SUBJECT: Request for Alternatives ANO1-R&R-005 and ANO1-R&R-006 -
Proposed Alternatives to ASME Weld Repair and Examination
Requirements for Repairs Performed on Reactor Vessel Head
Penetration Nozzles

Arkansas Nuclear One, Unit 1
Docket No. 50-313
License No. DPR-51

**RESPONSE TO NRC REQUEST FOR ADDITION INFORMATION
PERTAINING TO ANO1-R&R-005 & ANO1-R&R-006**

ARKANSAS NUCLEAR ONE, UNIT 1
REQUEST FOR ADDITIONAL INFORMATION
PERTAINING TO
REQUESTS FOR ALTERNATIVES ANO1-R&R-005 & ANO1-R&R-006

Figure 2: The flaw geometry with respect to the J-groove weld on the uphill side. The joint configuration is as follows:

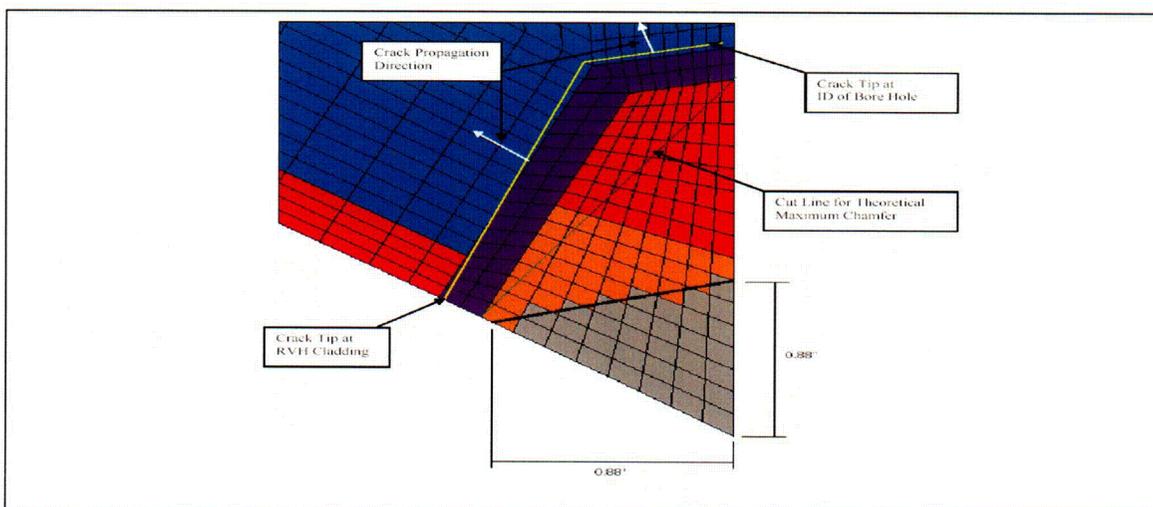
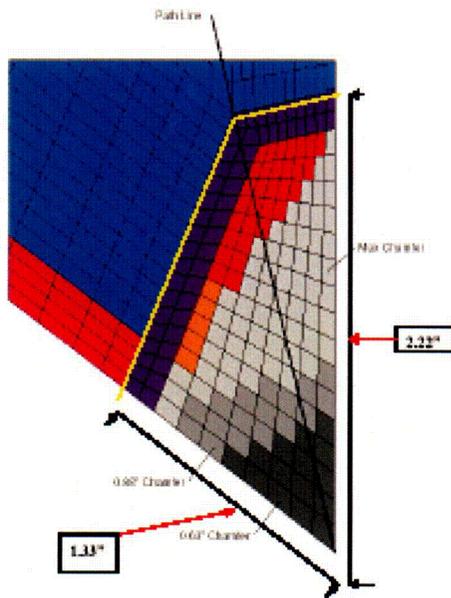
2. Page 4: Describe the flaw model in the revised fracture mechanics calculations:

a. Describe the location of the initial and final flaw.

The initial flaw is located at both the uphill and downhill locations. The entire J-groove weld prep (J-groove weld and butter) are assumed to be completely cracked. The figure below (obtained from Figure 2 of the technical report from Enclosure 2t) provides the flaw description at the uphill location. The downhill flaw can be described in a similar manner.

- 1) The J-groove weld is the trapezoid shown in red, light brown and grey color.
- 2) The purple color bounding the J-groove weld is the buttering layer.
- 3) The light blue color beyond the buttering layer is the low alloy steel reactor vessel head (RVH).
- 4) The magenta color strip is the stainless steel cladding on the RVH inside diameter (ID) surface.

- 1) The flaw tip (crack front) is along the interface between the buttering layer and the RVH (shown by yellow line)
- 2) Two flaw regions are marked; a) the design maximum chamfer case shown by the colored elements in red, light brown and the buttering in dark blue (note the chamfer size of 0.88 inch), and b) the maximum chamfer line shown in light turquoise color (the crack is the entire J-weld prep. **Note:** The design minimum chamfer size of 0.63 inch is not shown and would be of a size in-between the "no chamfer" and the design maximum chamfer geometry.
- 3) The "no chamfer" flaw would be composed of the grey, light brown, red, and purple colored elements.
- 4) The crack propagation direction is shown by white arrows.

The final flaw shape is not shown because the fatigue crack growth analysis showed that the growth estimated for one cycle of operation to be 0.005 inch. The fatigue crack growth analysis is presented in the technical report (Enclosure 2). The small extent of growth would not impact the initial flaw size considered in the analysis.

Uphill J-Groove Weld

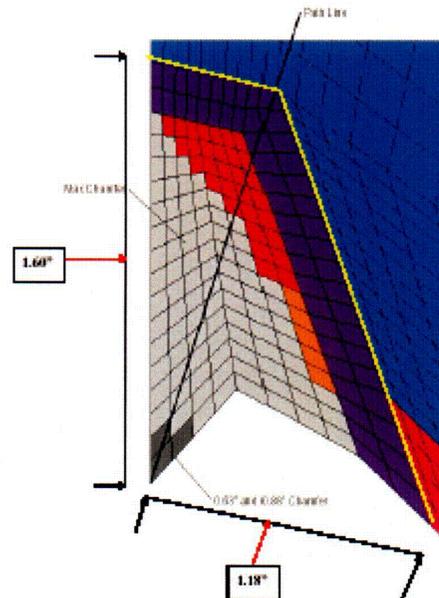
- b. Specify the length and depth of the initial flaw.

The length and depth of the flaw are the weld prep size for the uphill and downhill locations, which were modeled in the finite element analysis. The finite element models were developed based on design drawings. The weld prep design tolerance was included in the model development. The sketch below shows the weld dimensions and the approximate flaw shapes for the various chamfers considered in the analysis. The two sketches (uphill and downhill) provide the information for the initial flaw sizes considered in the analysis.

Sketch shows the uphill location, chamfer size and initial weld size. The initial flaw sizes for the various chamfer sizes are different. The yellow lines define the crack tip.

Sketch shows the downhill location, chamfer size and initial weld size. The initial flaw sizes for the various chamfer sizes are different. The yellow lines define the crack tip.

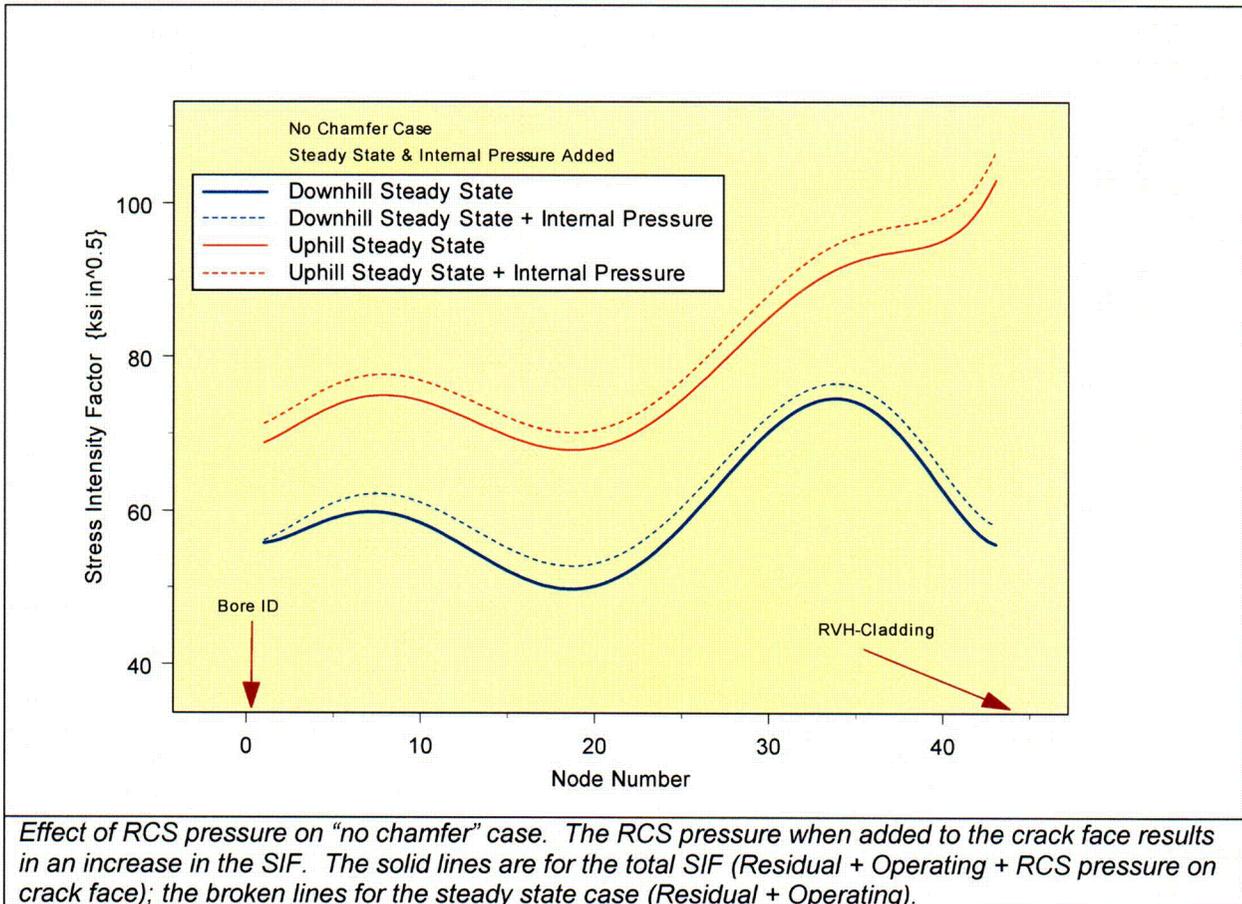
- a) Entergy stated that "...Relaxing the residual stresses due to cracking will not be utilized since the analysis will use a linear elastic formulation..." Clarify whether this approach will provide conservative results.

Relaxation of residual stresses as the crack grows has not been demonstrated by detailed analysis and benchmarked by experimental studies. Studies conducted for girth welds in carbon steel pipes (provided in Attachment 1 of this enclosure) have shown that welding introduces significant constraint, while simultaneously increasing the crack driving force. The analyses and experiments conducted for welded and unwelded pipes showed that the "J-integral" at failure initiation for the welded pipe was 63% lower than that for an unwelded pipe. This reduction was attributed to the significant constraint induced by the residual stress field. The experiments were carried out on flawed pipes.

Had relaxation of the residual stresses occurred during the creation of the flaw, prior to the fracture testing, the drop in the "J-integral" value at initiation for the welded pipe would not have been significantly lower than that for the unwelded pipe. This is further confirmed by testing performed on single-edge notch bend (SE-B) specimens. In this case, the specimen removed from the welded pipe showed a 26% drop in the "J-integral" at fracture initiation. The lower drop caused relaxation during the specimen removal operation. However, the specimen removal did not fully relax the residual stress; otherwise, there would have been an insignificant drop in the "J-integral" value at fracture initiation. The information presented in this study (provided in Attachment 1) indicates that residual stresses do not relax as the crack propagates, because relaxation of residual stresses would manifest as a reduction in the constraint, which was not observed.

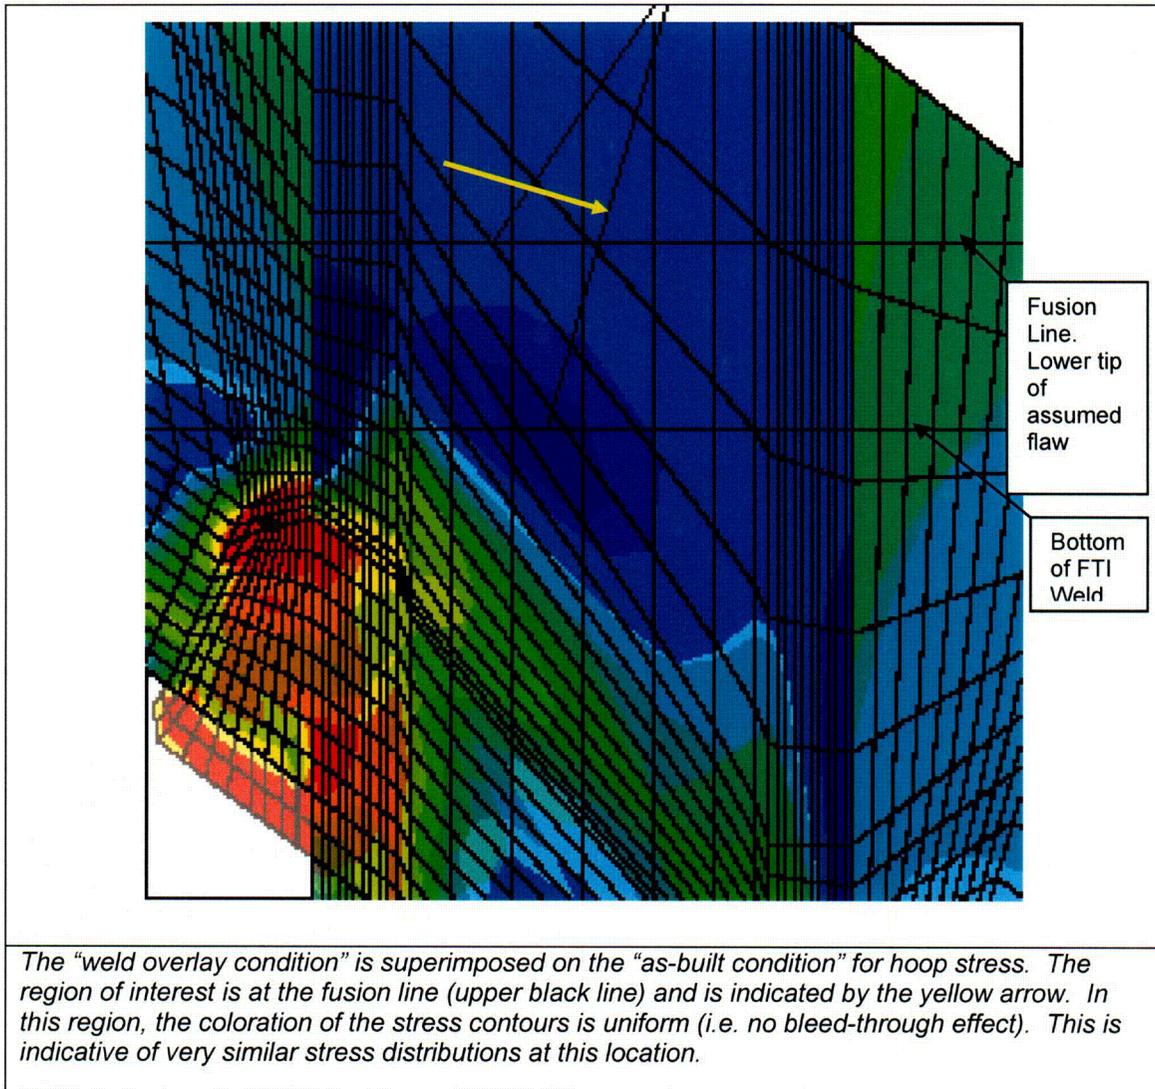
14. It seems that Entergy has not provided sufficient technical basis to demonstrate the structural adequacy of installing an FTI weld repair on a weld overlay repaired nozzle. Entergy compared only the hoop stresses of an as-built nozzle configuration to the hoop stresses of a J-groove overlay weld configuration. Entergy should have compared the hoop stresses of an FTI weld repair on an overlay repaired nozzle to the hoop stresses of an FTI weld repair on an as-built nozzle. If the hoop stresses are comparable between two models, then Entergy can conclude that the FTI weld repair is acceptable to be installed on an overlay repaired nozzle, assuming other analytical parameters between the two models are comparable. Entergy needs to clarify its technical basis.

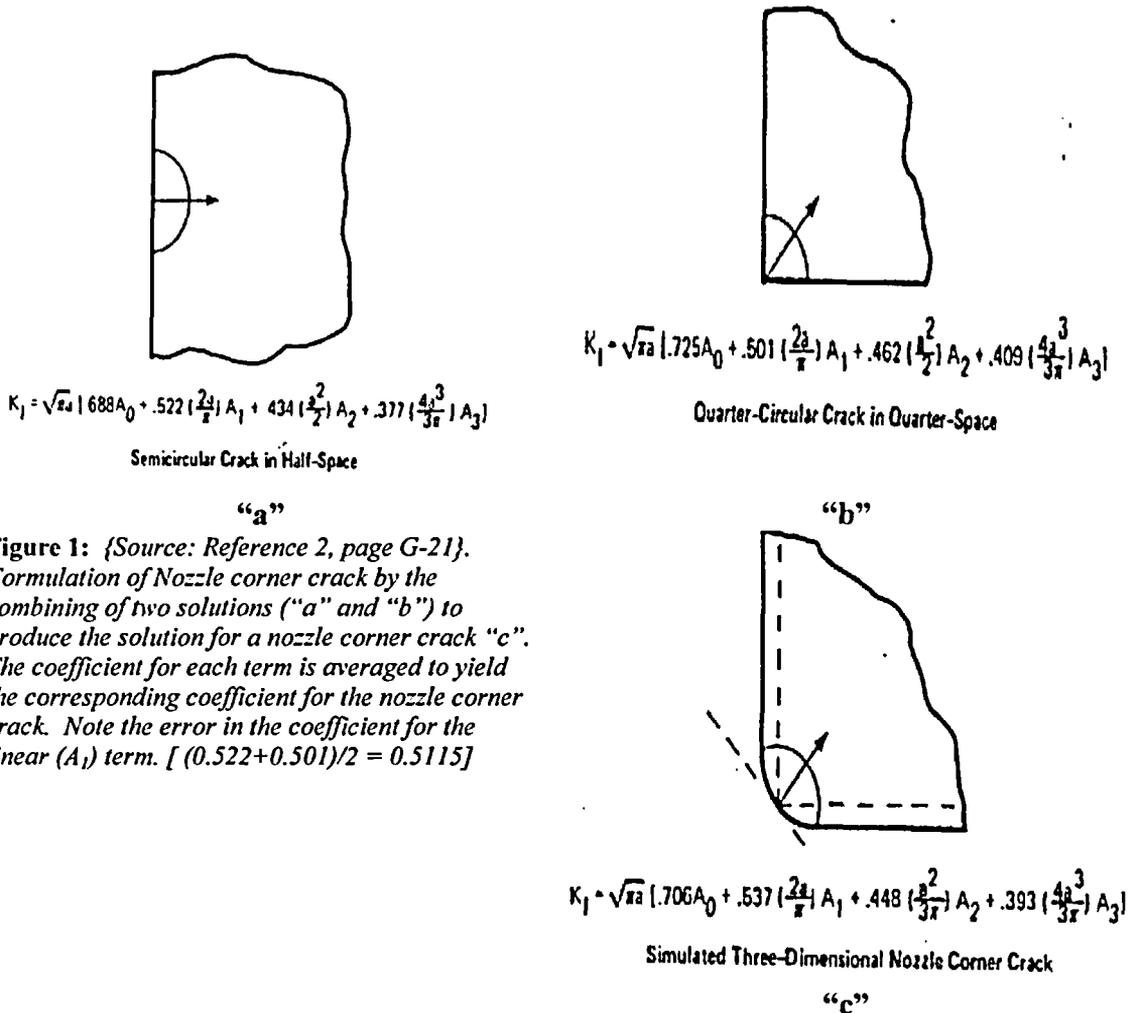
Concern 1: The stress intensity factor (SIF) equation, used in the analysis of the J-groove weld flaw, in Reference 1 was obtained from Reference 2. The formulation, Figure 1, was a combination of two influence function solutions. The two solutions used to derive a solution [2] for the corner flaw in a nozzle were:

- a) A semi-circular crack on a half-space (upper left in Figure 1); and,
- b) A quarter-circular crack in a quarter-space (upper right in Figure 1).

The derivation for the corner crack for a nozzle consisted of averaging the coefficients from the two equations for the two other crack models described above. The coefficients for the nozzle corner flaw are shown in the lower right sketch of Figure 1. The averaging of the two coefficients for the linear term (A_1) appears to be in error. The average of the coefficients from the two base models results in a value of 0.511 for the resulting coefficient, whereas the value in the equation is 0.537.

The publication, cited in Reference 2, was published at the request of the ASME Nuclear Codes and Standards Department to provide the information to utility members. The foreword to this publication clearly states that; "*The solutions provided herein are for information only*". Furthermore, the reference cited for this formulation is a personal communication between two individuals. There is no cited reference that provides an analytical basis for the formulation.
